CITY OF BETHLEHEM

HARB CERTIFICATE OF APPROPRIATENESS

HARB MEETING MINUTES AND SUBMISSION

Item #1: The applicant/owner of the property located at 555 Main Street proposes to construct additional stories above the existing building.

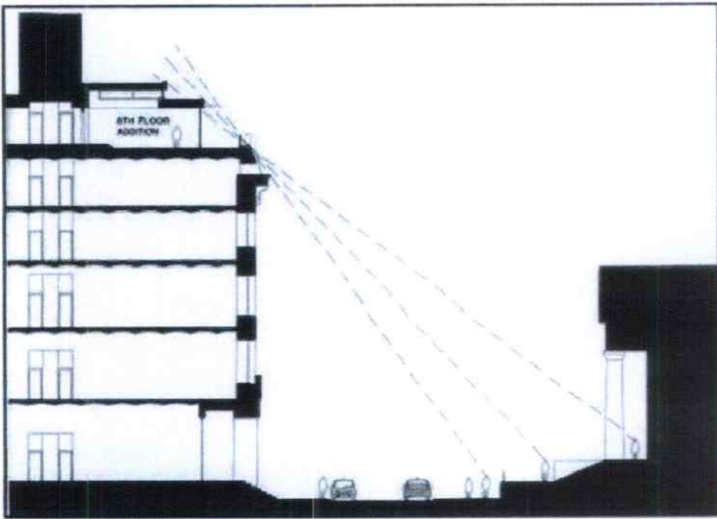
- These points must be kept in mind as the Application is reviewed
- Chapter 14, page 12 specifically discusses rooftop additions. Page 13, Figure 24 illustrates how to evaluate sight line studies for a rooftop addition

- Based on this guideline, the addition should be limited to one story in the front and the setback would need to be increased due to the roofline of the adjoining building

Figure 24, then an addition of more than one story may be something that could be considered. Rod Young stated that the guidelines say no addition, but he could support a one-story addition and is open to creative solutions. Joe McGavin recommended flagging the proposed addition and photographing the flags to determine the view of the proposed addition from the street. The Applicant's attorney stated that she feels an alternative/revised design could be prepared and asked how quickly they could come back before HARB. She was advised that the next HARB meeting is on Wednesday 2 April 2025.

Chapter 14 Page 13 Figure 24 which is a graphic to illustrate how to evaluate sight line studies for a rooftop addition. Based on this guideline the addition needs to be limited to 1 story in the front

1. Investigate the height of the proposed addition. HARB prefers a one-story addition, but is open to solutions that comply with Figure 24 found in Preservation Brief 14 with and emphasis on the primary elevation of the addition that faces Main Street.
2. Explore setbacks of the rooftop addition on the West and South Elevations that will clearly distinguish the addition from the existing building.
3. Explore materiality on the facades of the addition. The materials on rear façade should be more compatible with, but distinguishable from the materials on the existing and adjacent buildings.
